Roundabout Design Report

Re: Lorson Ranch East
Roundabout Report
El Paso County, CO
LSC #164360

Figure 10

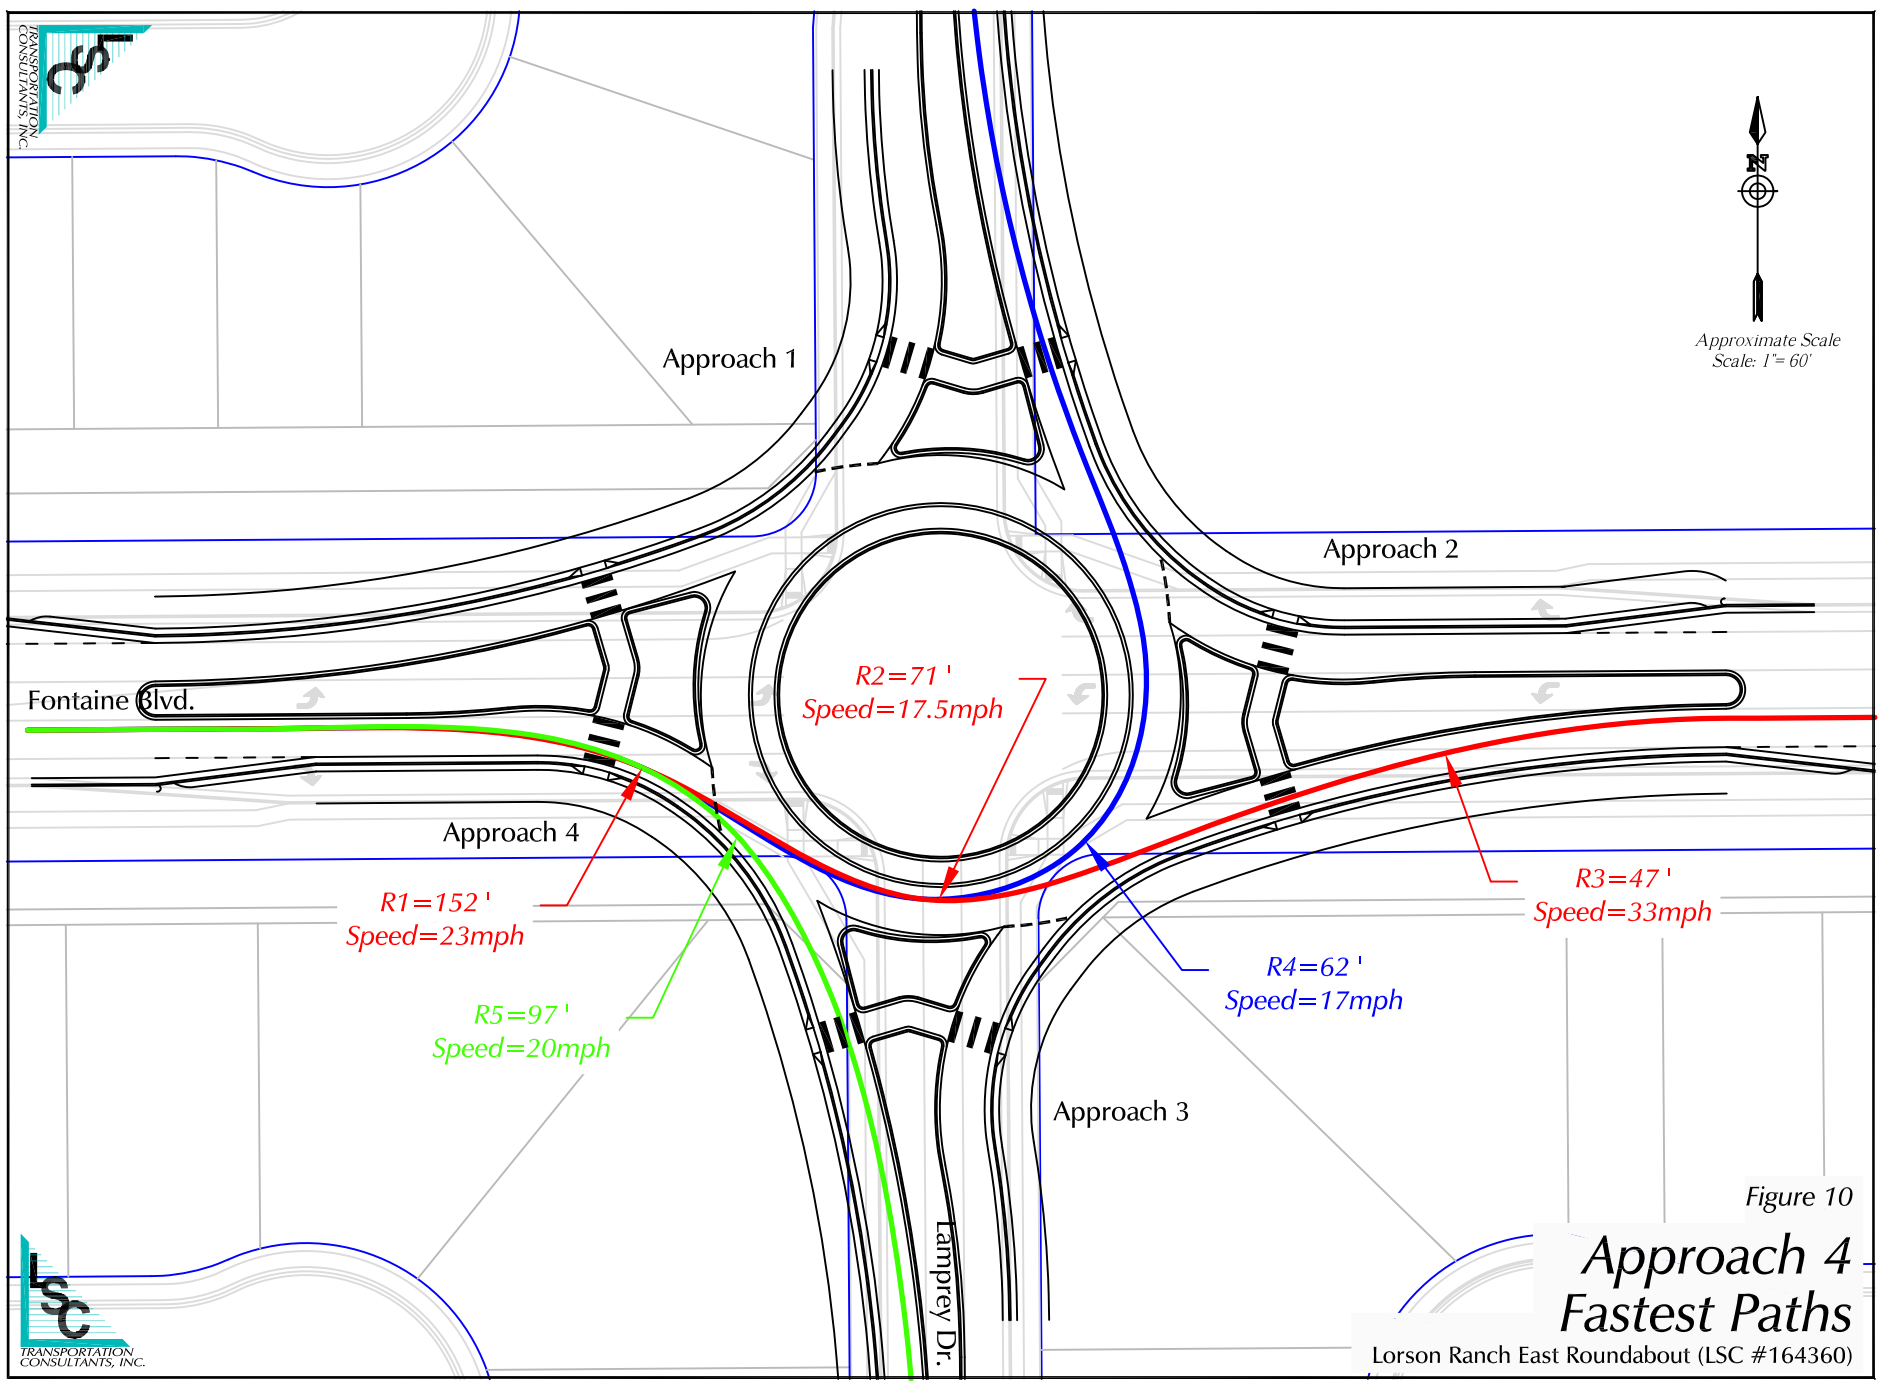
Has it been revised?

15.5 and 17 per FDM 30.5.23

Figure 11
**Sight
Triangles**

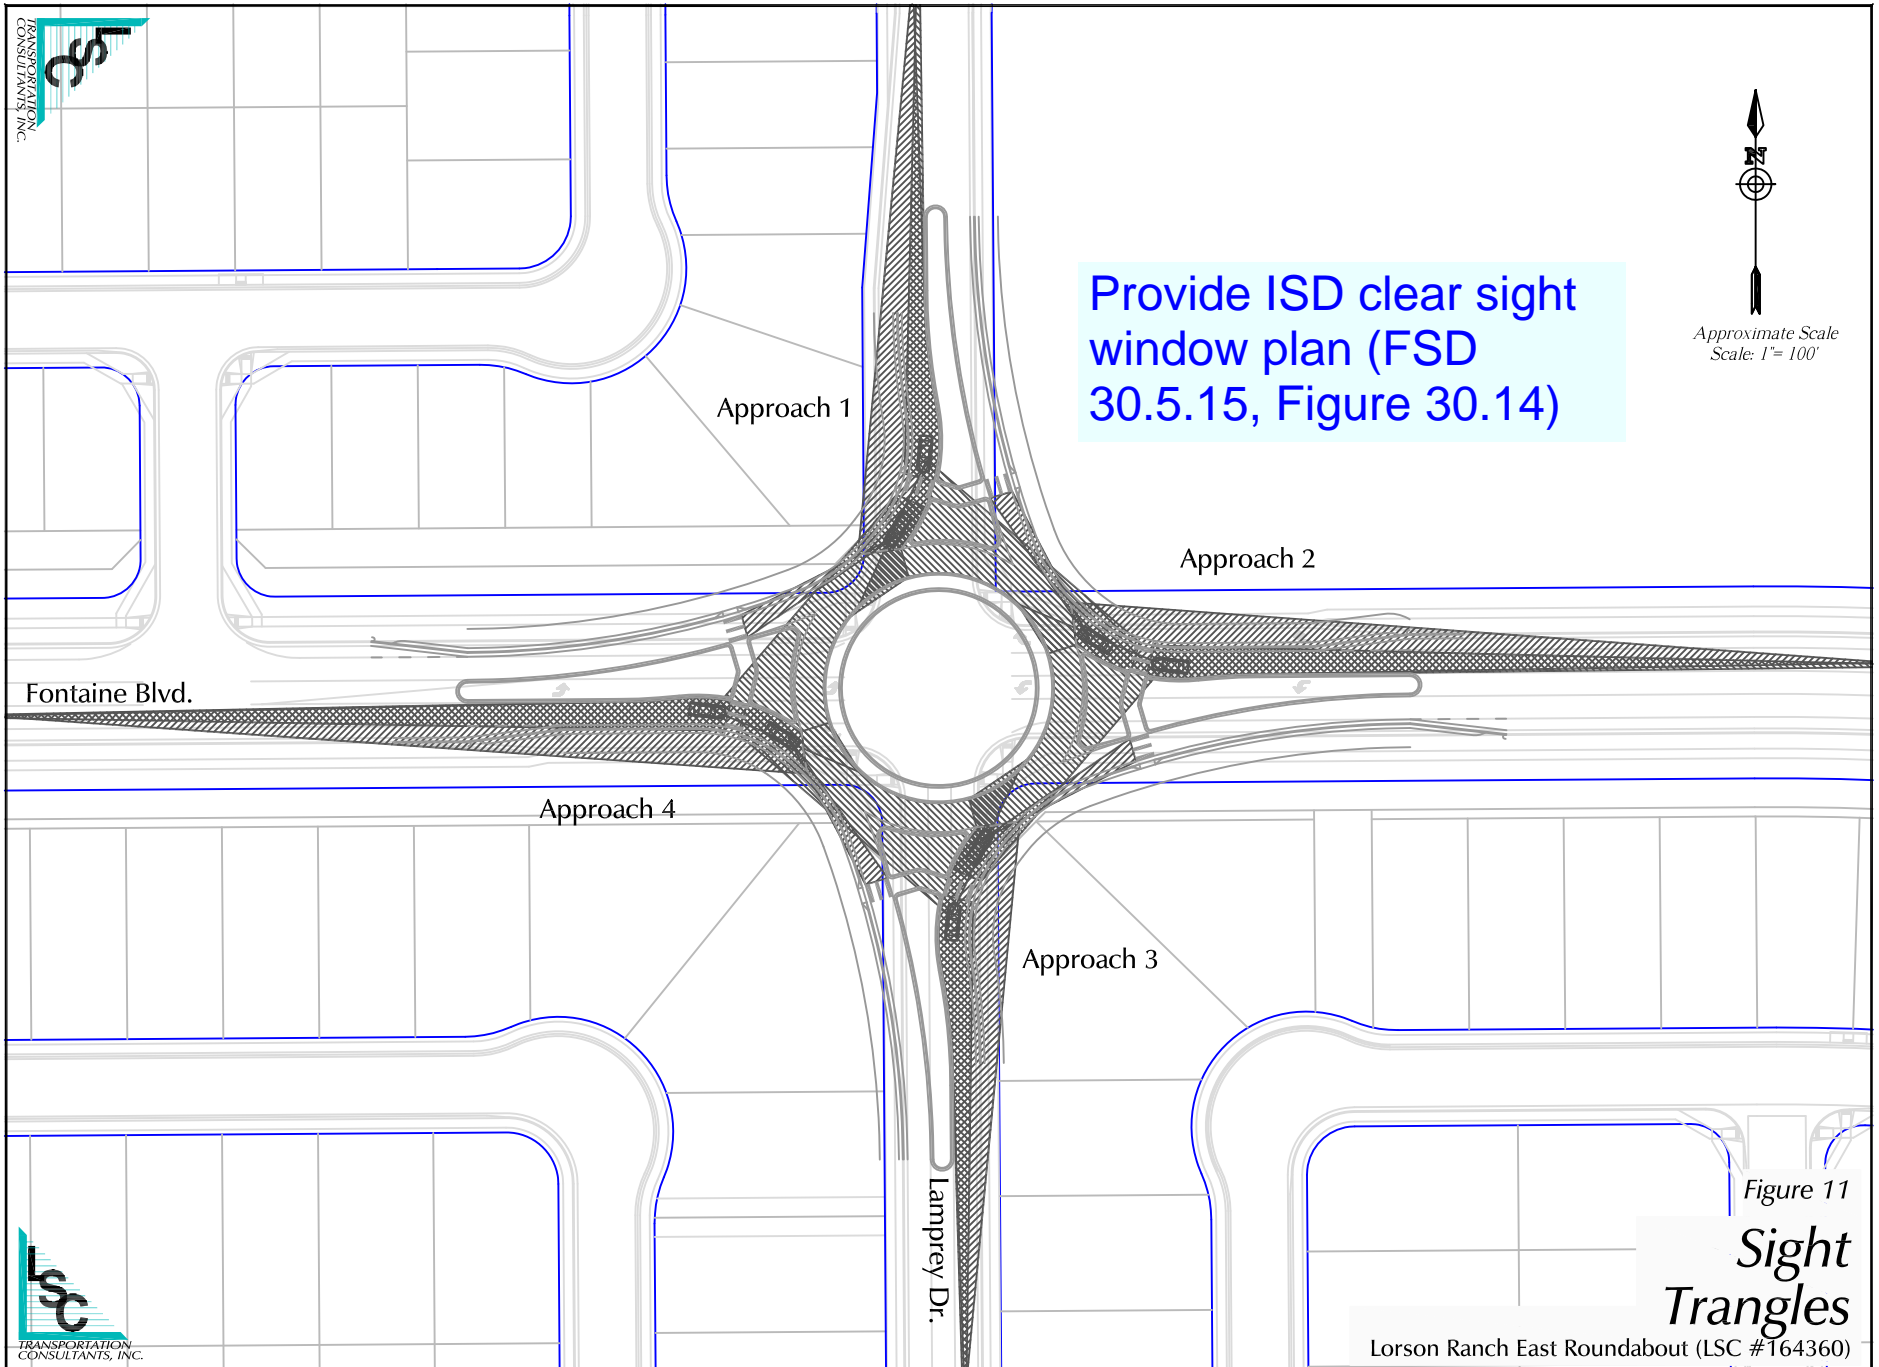
Address sight distance control/clear sight window limits.

Provide ISD clear sight window plan (FSD 30.5.15, Figure 30.14)
